UNITED STATES
NUCLEAR REGULATORY COMMISSION
WASHINGTON, D.C. 20555-0001

SUBJECT: REACTOR OVERSIGHT PROCESS SUMMARY OF PUBLIC
MEETING HELD ON JUNE 14, 2000

On June 14, 2000, a public meeting was held at the NRC Headquarters, Two White Flint North, Rockville, MD to discuss the Reactor Oversight Process initial implementation. An agenda of the meeting, the attendance list, and information exchanged at the meeting are attached.

Attachment 4

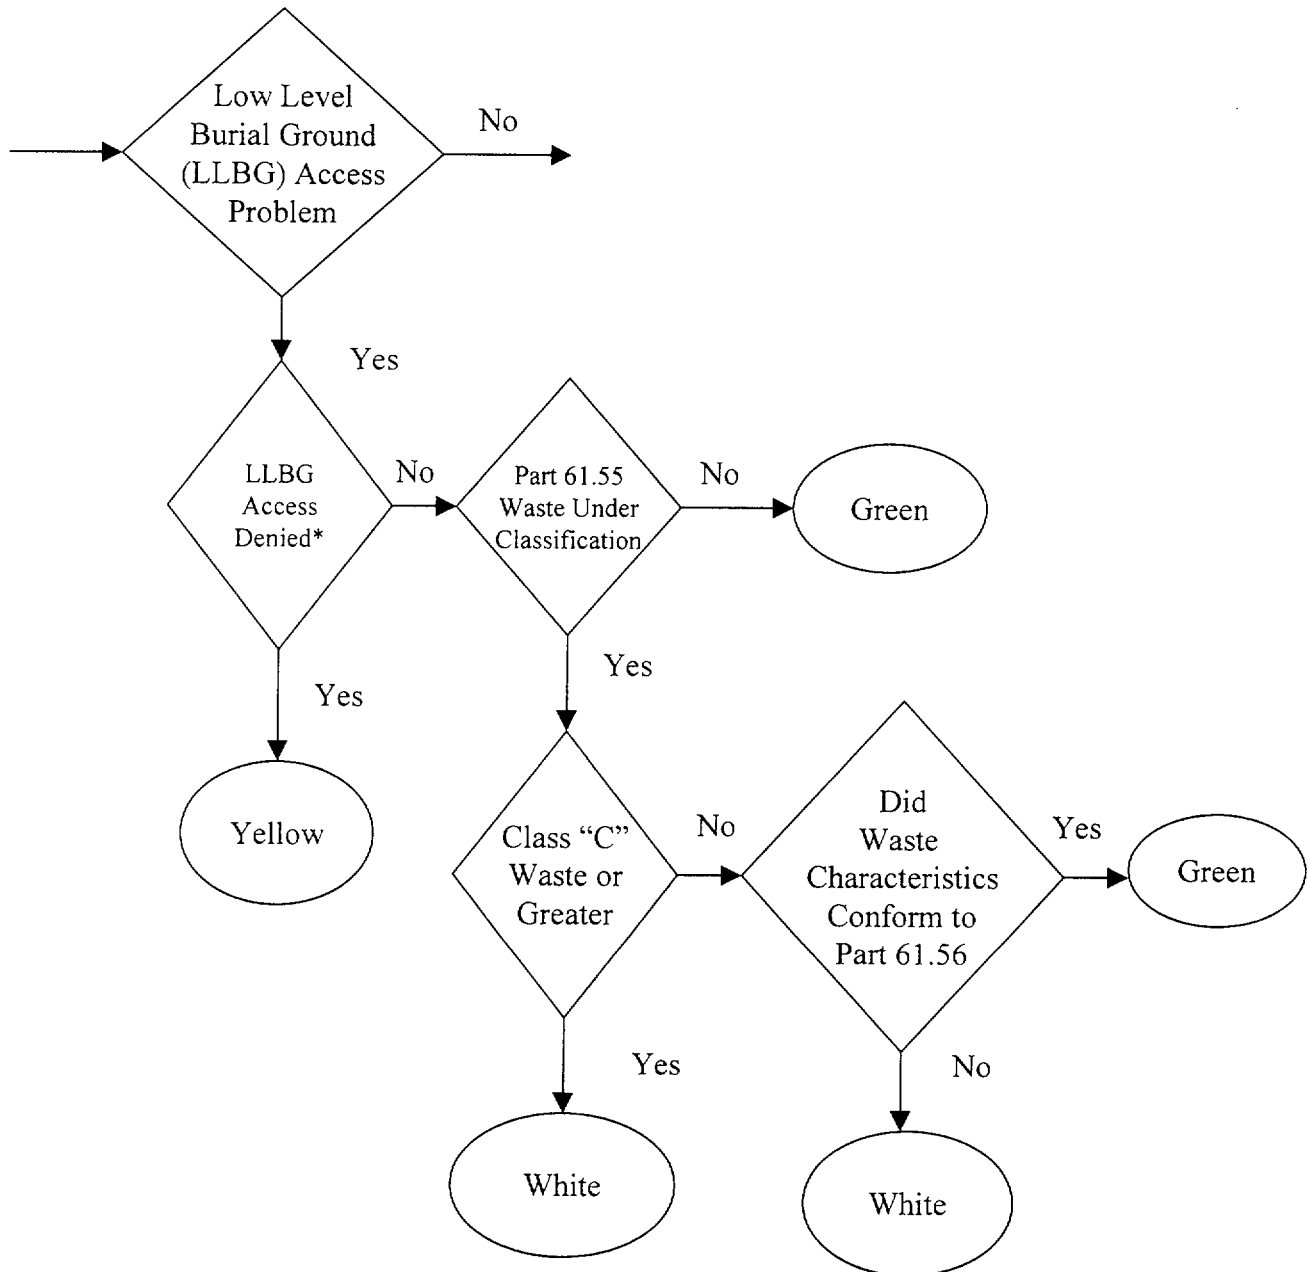
REPLACE W/Ⓐ

Rapid Shutdowns Per 7000Hrs (4qtr avg)

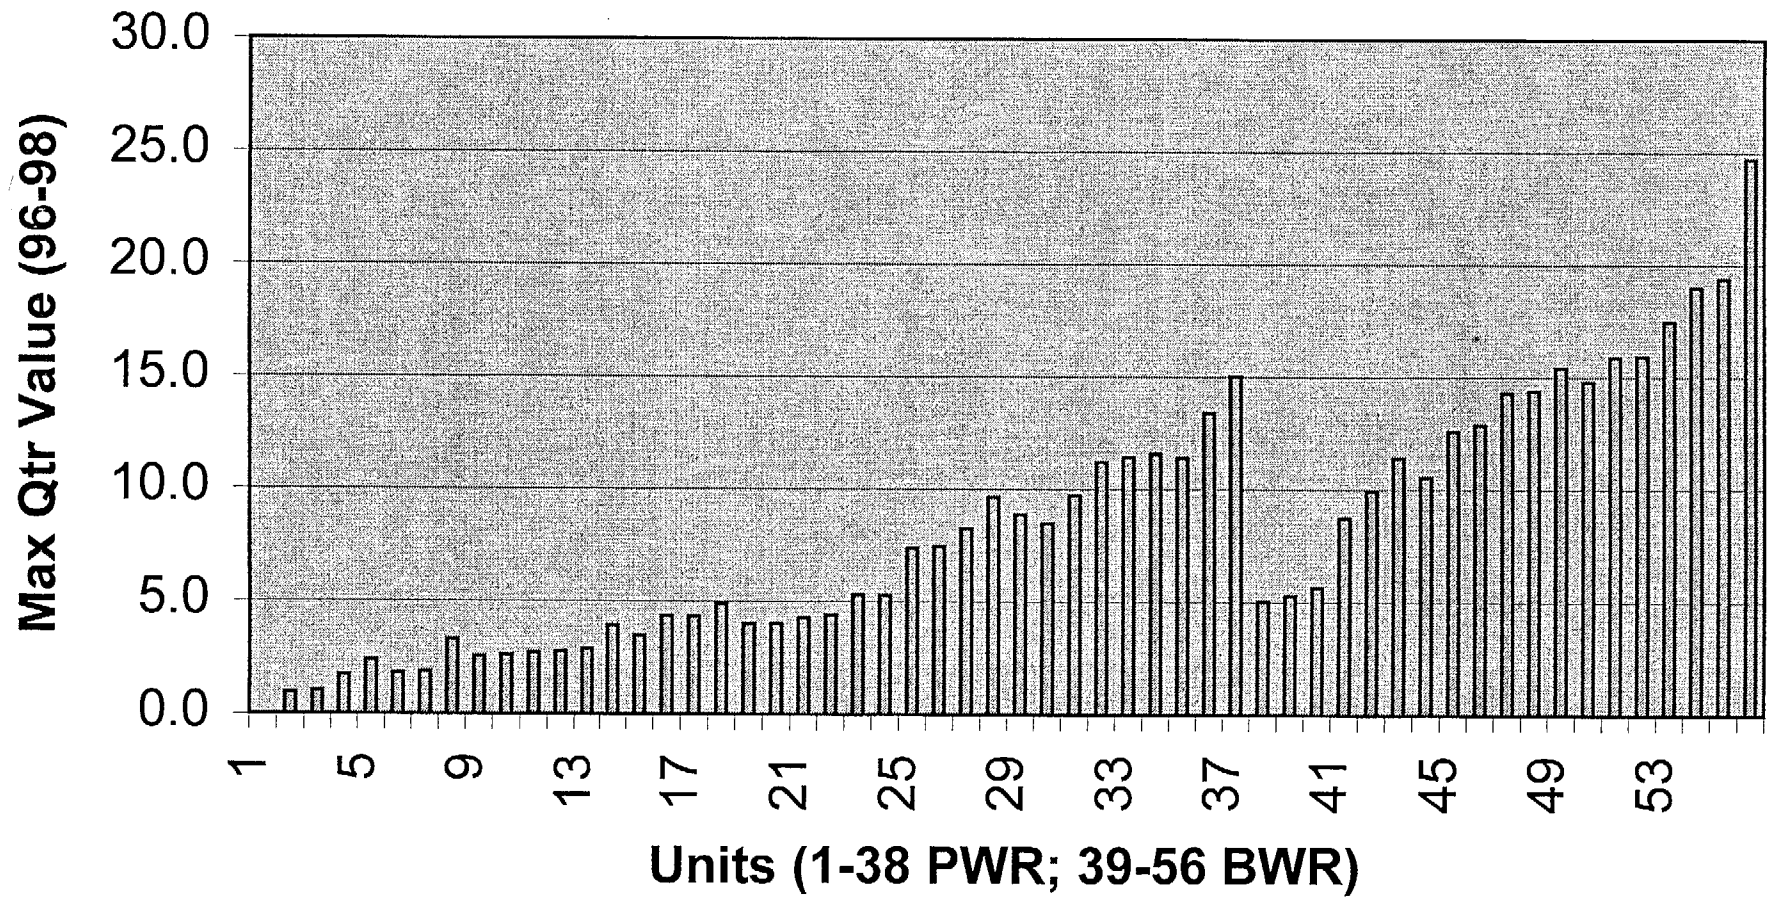
- Based on our review of the data, the industry recommends keeping the indicator as it currently exists for the following reasons:
 - Plant design differences create an uneven playing field not indicative of plant performance
